MODIFICATION No. 23554P3127

TITLE : AIR CONDITIONING - COCKPIT - INTRODUCE PROTECTION AGAINST WATER CONDENSATION.

SERVICE BULLETIN No. : A320-21-1072

Modification of the Instrument Panel Blanking Plate
Figure 4

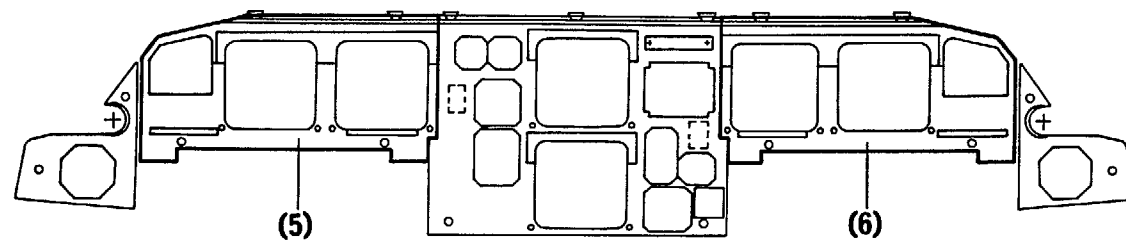
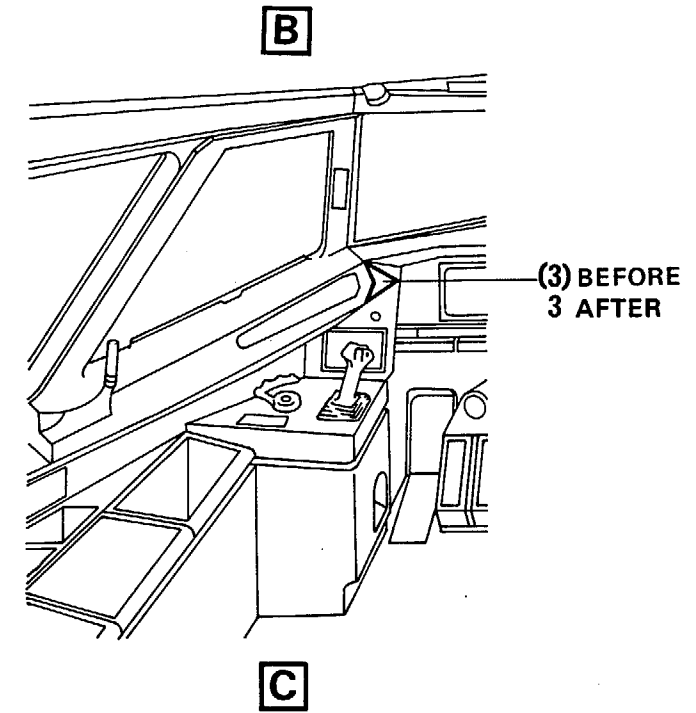
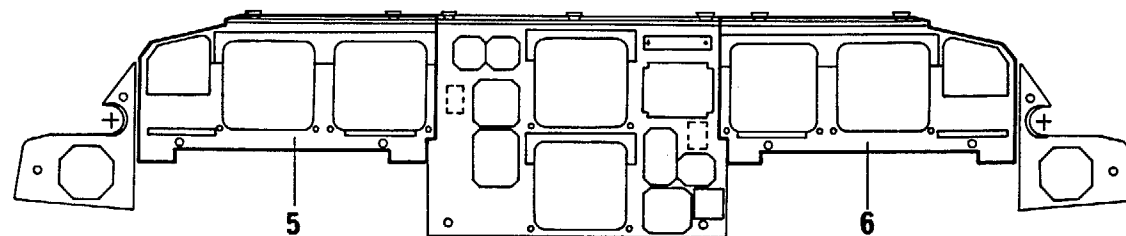
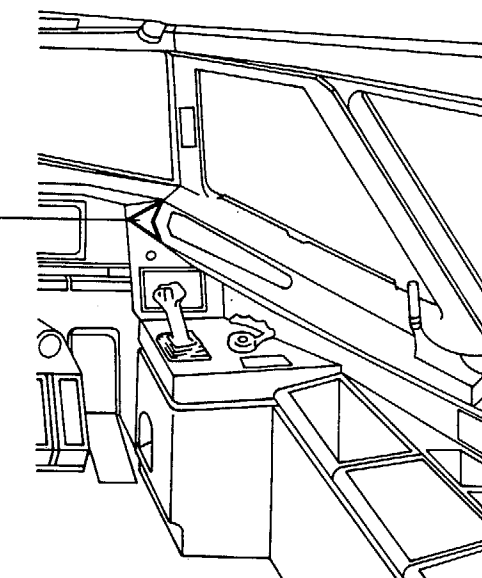
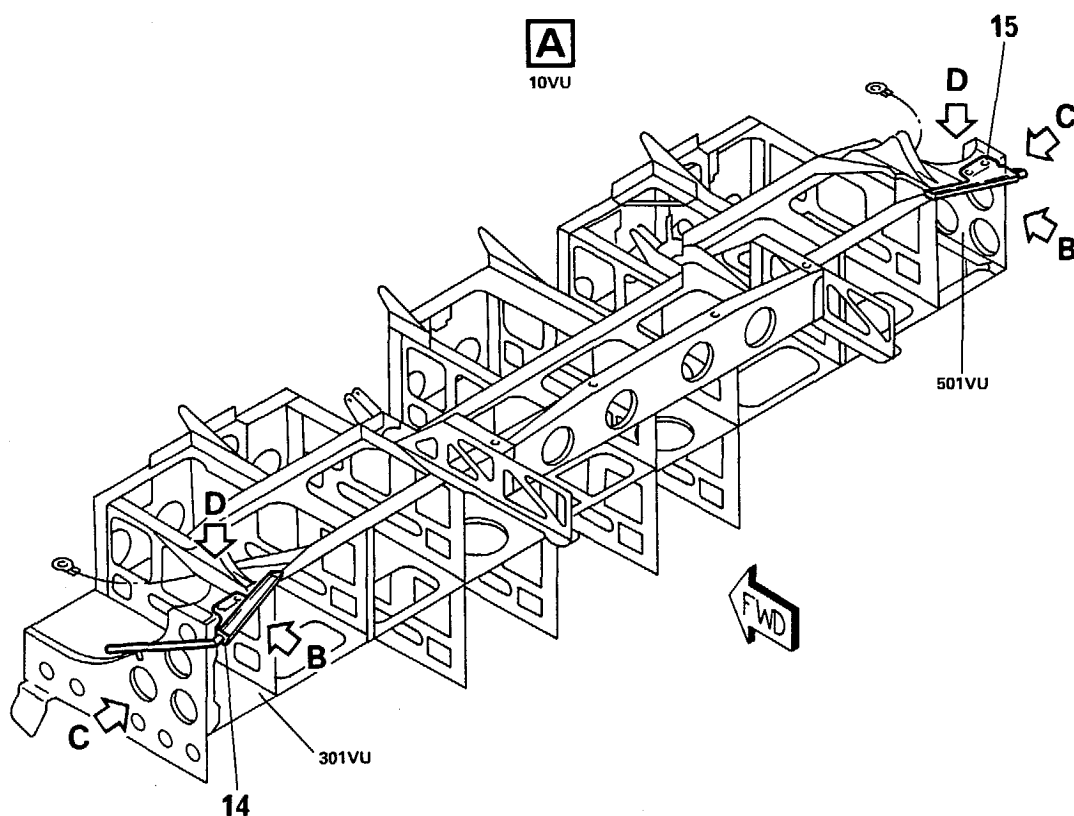
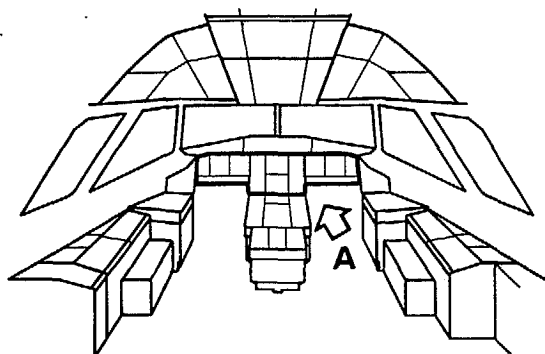
- (4) In the cockpit, removal of the instrument panel blanking plate

1 panel assy	Item (3) (discard)
1 panel assy	Item (4) (discard)
1 cover assy	Item (5) (discard)
1 cover assy	Item (6) (discard)

1 panel assy	D2511157000000	Item 3
1 panel assy	D2511157000100	Item 4
1 cover assy	D2511158100000	Item 5
1 cover assy	D2511158100100	Item 6

Installation of a Trough under the Lower Post of the Front Window
Frame at 301VU and 500VU
Figure 5, Sheet 1 of 3

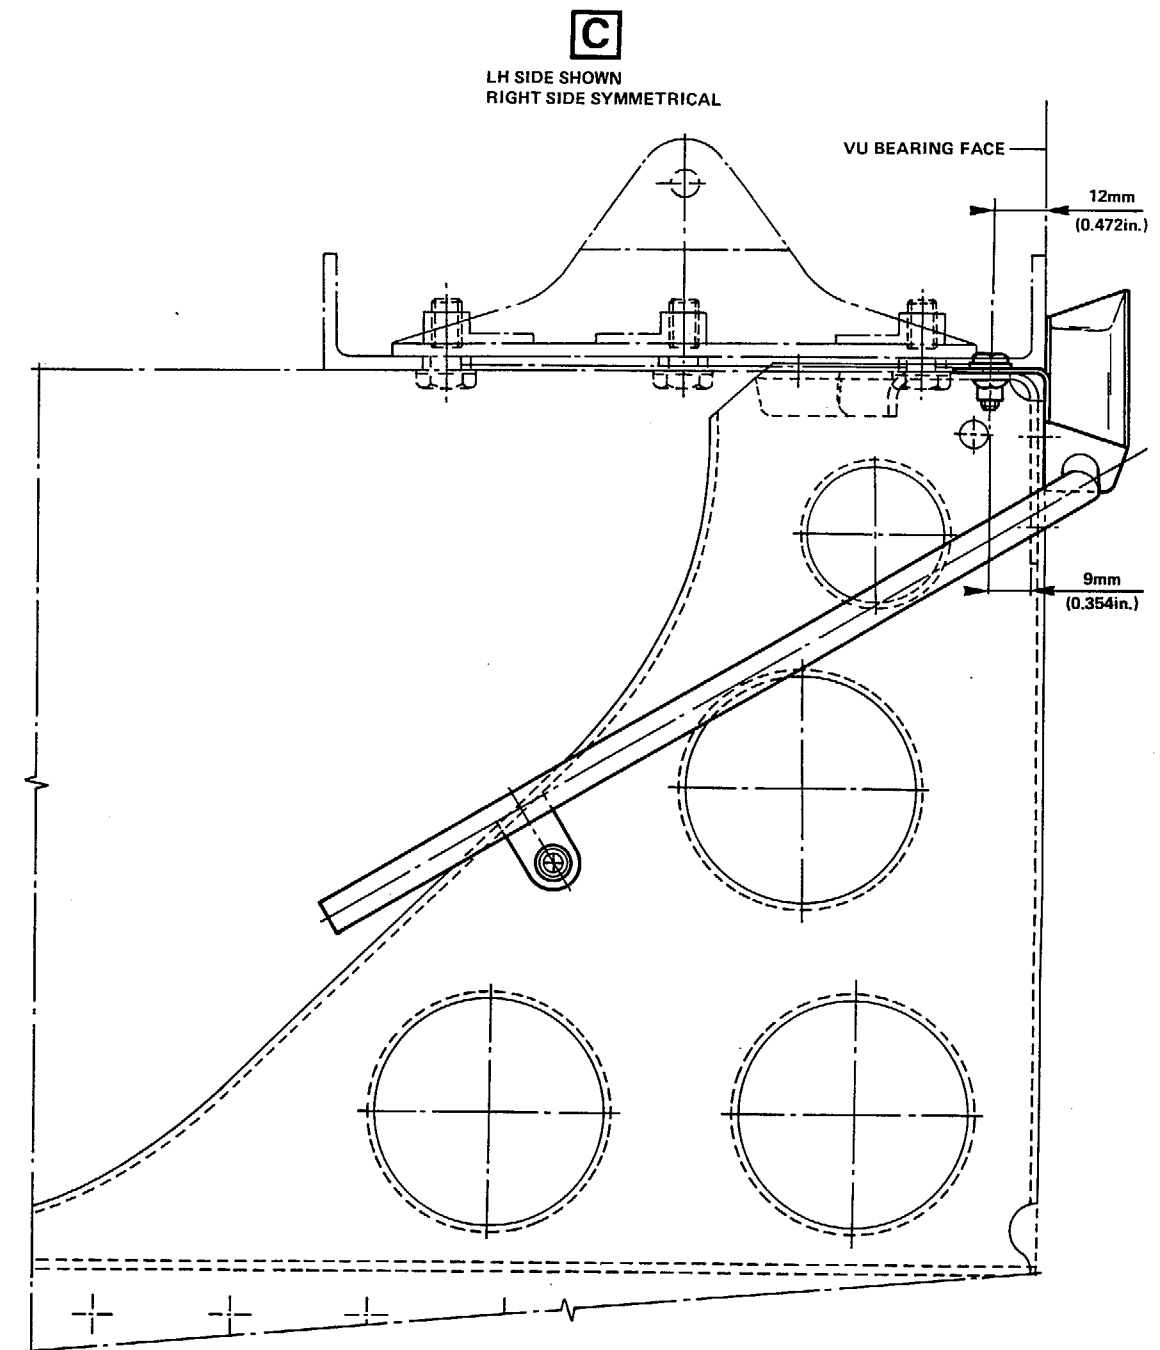
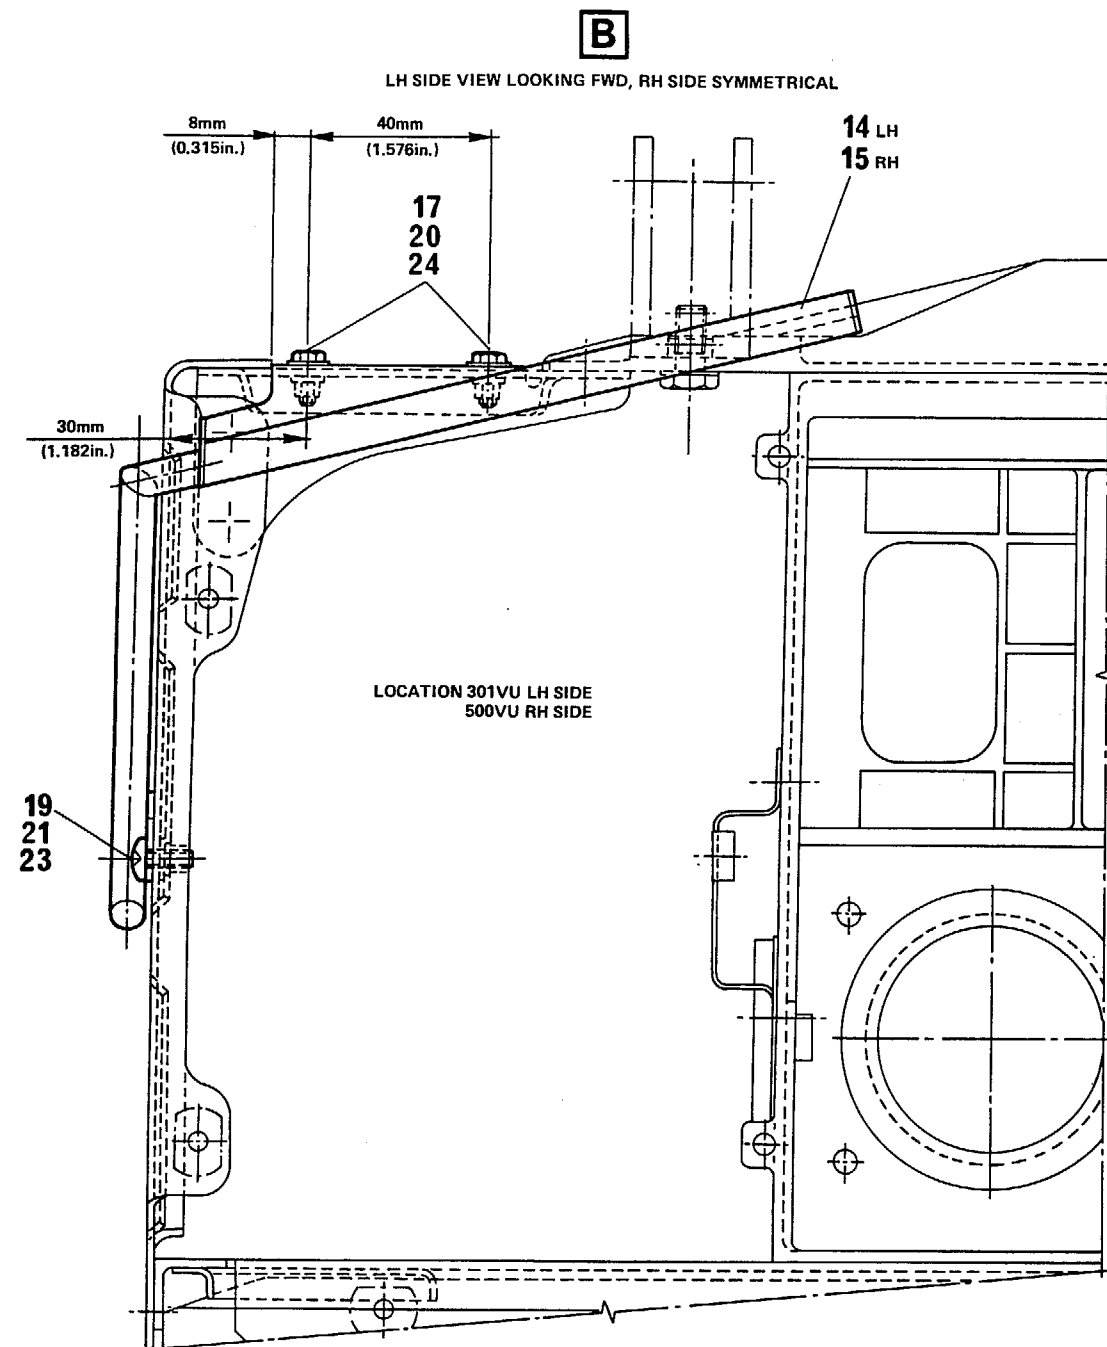
- (5) Installation of a trough under the lower post of the front window frame at 301VU and 500VU

- (a) On the structure 10VU, left and right sides, refer to the specified dimensions, make marks and drill the 3.2 mm (0.126 in.) holes to the intermediate diameter.
- (b) Put the trough assies Items 14 and 15 in position on the structure 10VU. Align the hole that is on the trough and on the sides of the structure 10VU.
- (c) Temporarily, attach the trough assies and drill the 4 mm (0.157 in.) holes to the final diameters.
- (d) Remove the trough assies, clean and deburr.

1 trough assy	D9251277800000	Item 14
1 trough assy	D9251277800100	Item 15
2 + 2 screws	NAS1096-1-5	Item 17
1 + 1 screw	NAS1100-08-10	Item 19
2 + 2 washers	ASNA2397-6L	Item 20
1 + 1 washer	ASNA2397-8	Item 21
1 + 1 nut	MS21042-08	Item 23
2 + 2 nuts	MS21042-06	Item 24

Modification of Drain Line under L and R Lower Windshield Front Section
Figure 6, Sheet 1 of 2 .

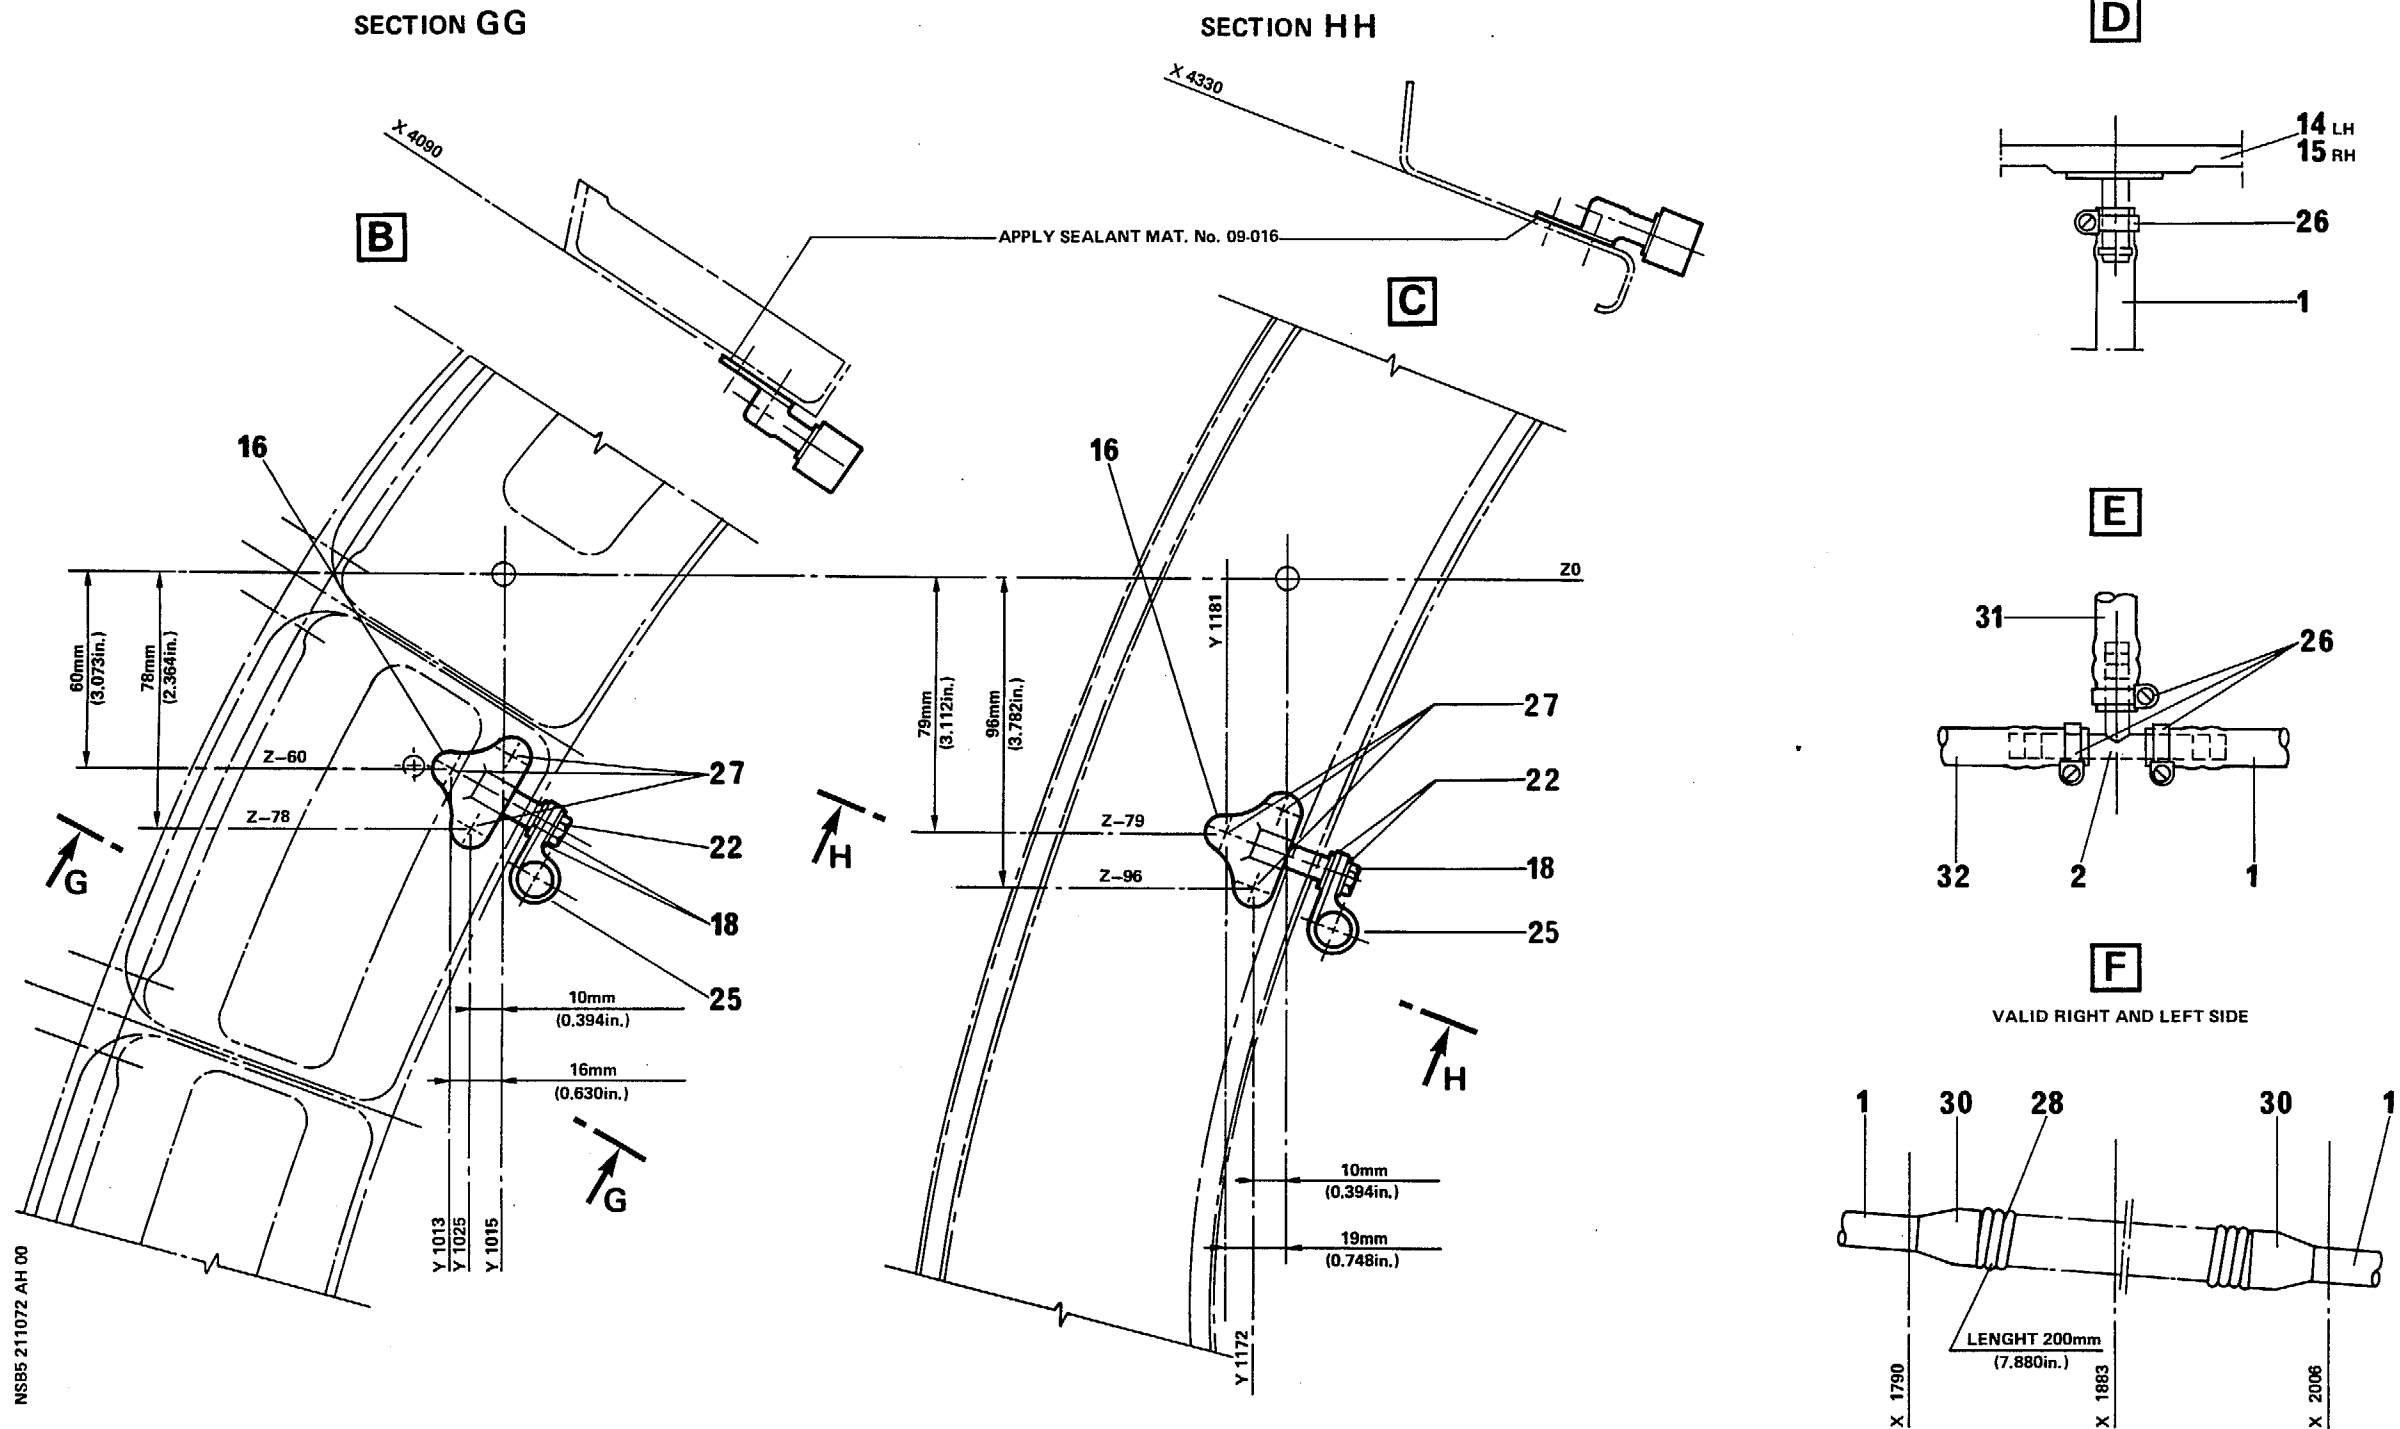
(6) Modification of the drain line under the L and R lower windshield front sections

(a) On FR3 and FR4, left and right sides, refer to the specified dimensions, put in position and drill the 3.2 mm (0.126 in.) dia. holes on the structure to match the holes on the bracket Item 16 (Details B and C).

2 + 2 brackets	ASNA2328-3-4	Item 16
6 + 6 rivets	ASNA2050DCJ3215	Item 27

2 + 2 screws	NAS1096-3-10	Item 18
4 + 4 washers	ASNA2397-10L	Item 22
2 + 2 clamps	NSA5515-7	Item 25

Modification of Drain Line under L and R Lower Windshield Front Section
Figure 6, Sheet 2

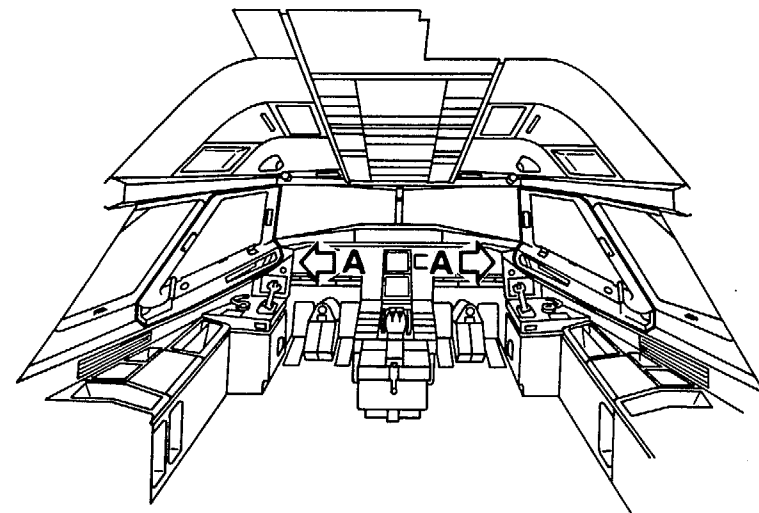
- (g) On the pipes that are in the aircraft, on the left and right sides, Item (35) cut and install :

D21210698212 Item (35) becomes A2181060420200 Item 31 and
D2121069821100 Item 32.

3 + 3 clamps ASNA0033-022 Item 26
